# 5.0 Restoring the Mill House

## 6.0 Design Development

### 6.3 Pre-Application Feedback

IF\_DO submitted Pre-application plans to Mid Suffolk District Council in February 2023 (DC/23/01017). The Pre-App response assessed the scheme as ‘a new dwelling in the countryside’, rather than a replacement dwelling, which is not deemed acceptable in accordance with the Development Plan.

*Above right:* Sketch massing model showing the reworked scheme following the pre-application feedback.

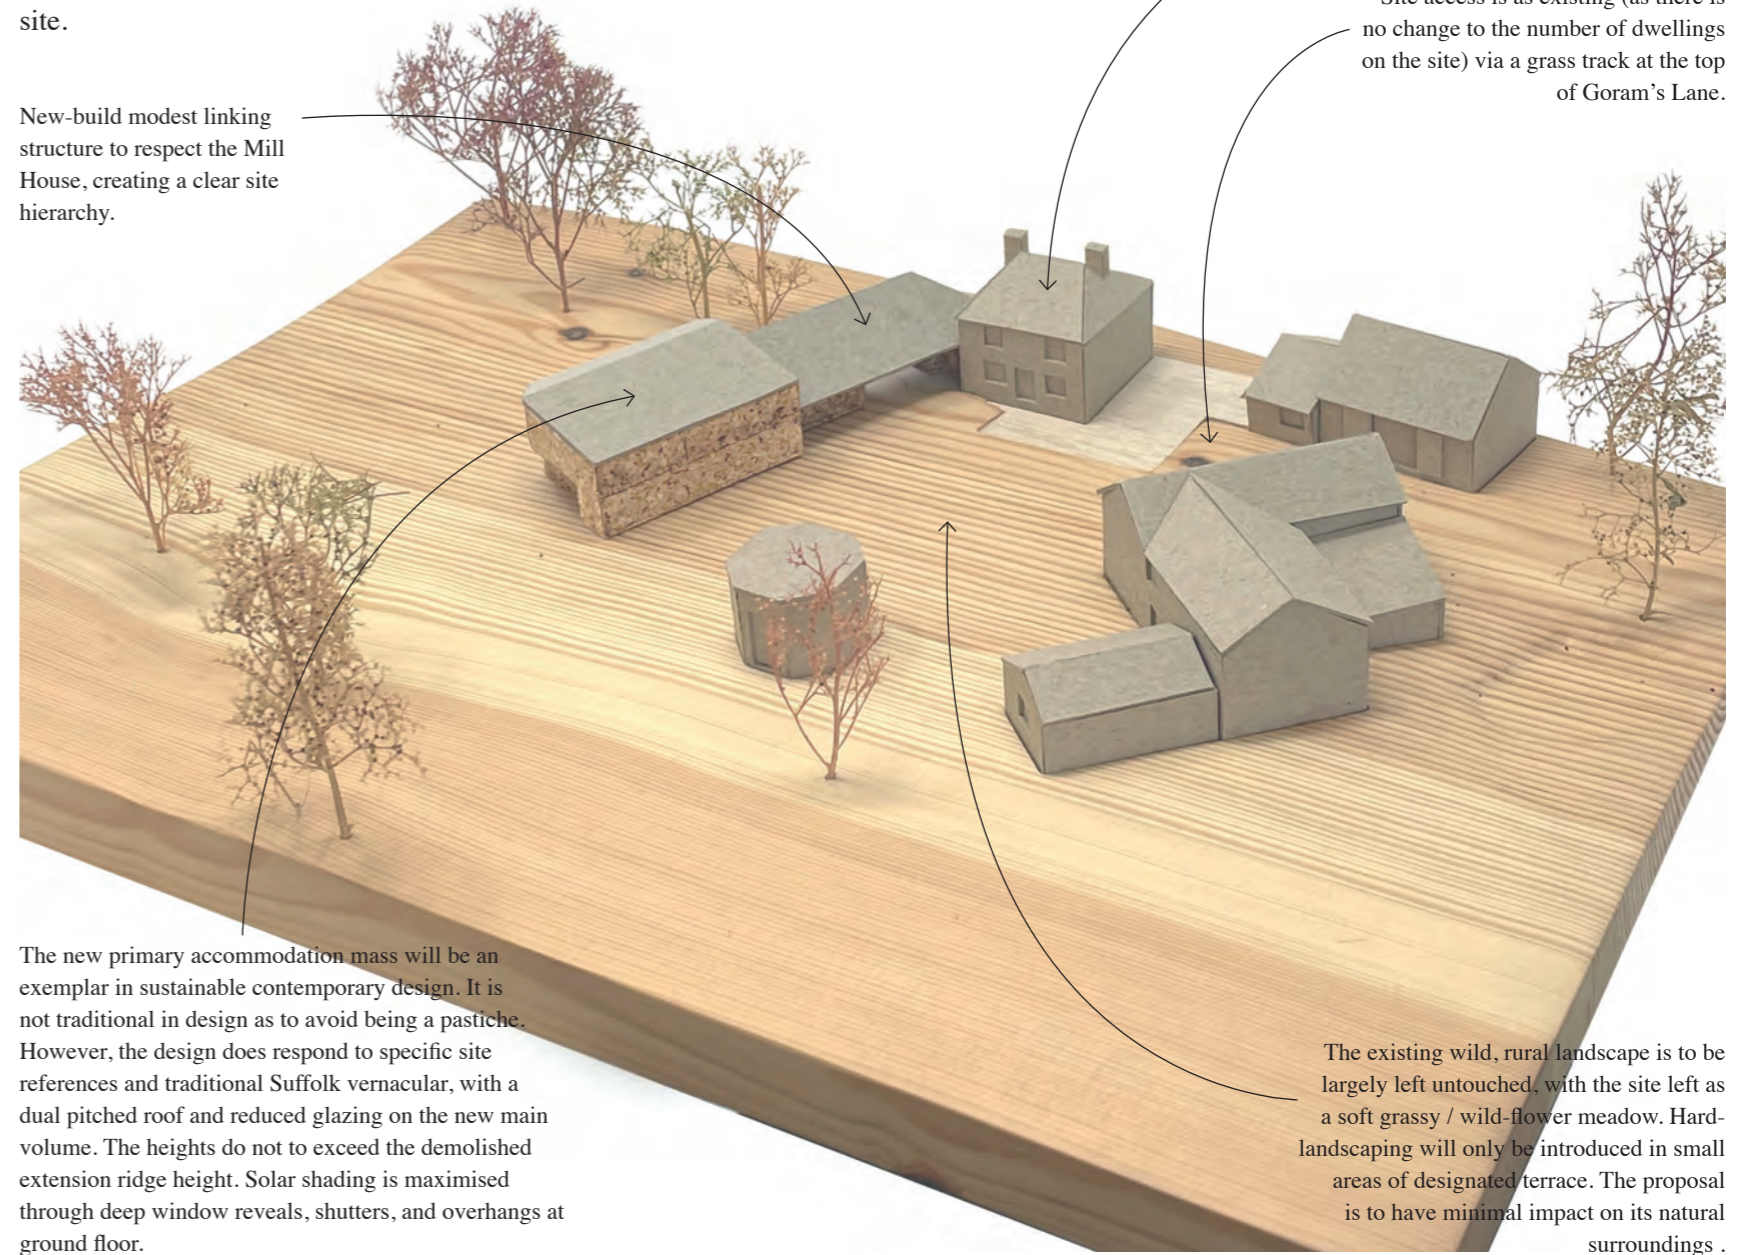
- A new dwelling in the countryside is not acceptable in accordance with the Development Plan.
- The Pre-App response identifies the Mill House as a potential non-designated heritage asset and so heritage advice should be sought (*see Heritage Impact Statement by Historic Buildings Studio*).

- Demolition of part of the existing dwelling is likely to be seen as acceptable, subject to it being deemed no harm is caused to a potential non-designated heritage asset.

- The feedback describes the Pre-App design as ‘ultra-modern’, including a large amount of glazing and a non-traditional style of dwelling. It is suggested that a more traditional style of dwelling, with a dual pitched roof and less glazing, might be more appropriate.

- The landscaping scheme should assimilate into the surrounding, responding to the character, biodiversity and heritage of the site, and mitigating impact.

- Due to the ponds, a Preliminary Ecological Appraisal is required (*see Preliminary Ecological Assessment by ROAVR Group*).
- The feedback queried if new access is required, and how this will impact on highways and site parking. This is not applicable in this case as the site access is to remain as existing (as there is no change to the number of dwellings on the site) via a grass track at the top of Goram’s Lane. This means there is no change to the number of private motor vehicles accessing the site. Consideration will be given in the proposal for new provision of electric vehicle charging points.

- Due to the layout of the dwelling, direct views into the private amenity space would be limited and would not likely warrant refusal. There is also ample amenity space around the proposed dwelling.

- The site is considered to contribute to the economy through the creation of construction jobs. However, it is noted that once occupied, there would be little economic benefit to Laxfield. We would dispute this as the proposal is to be an exemplar in sustainable design using locally based building company - Natural Building Systems.

The Pre-App response assessed the scheme as ‘a new dwelling in the countryside’. The proposal has since been reworked to ensure it is a replacement dwelling by physically linking to the existing Mill House and reducing sprawl on the site. Following the development there would still only be one dwelling on the site.

New-build modest linking structure to respect the Mill House, creating a clear site hierarchy.

Mill House reduced to the purity of its original design for use as ancillary accommodation.

Site access is as existing (as there is no change to the number of dwellings on the site) via a grass track at the top of Goram’s Lane.

The new primary accommodation mass will be an exemplar in sustainable contemporary design. It is not traditional in design as to avoid being a pastiche. However, the design does respond to specific site references and traditional Suffolk vernacular, with a dual pitched roof and reduced glazing on the new main volume. The heights do not to exceed the demolished extension ridge height. Solar shading is maximised through deep window reveals, shutters, and overhangs at ground floor.

The existing wild, rural landscape is to be largely left untouched, with the site left as a soft grassy / wild-flower meadow. Hard-landscaping will only be introduced in small areas of designated terrace. The proposal is to have minimal impact on its natural surroundings.
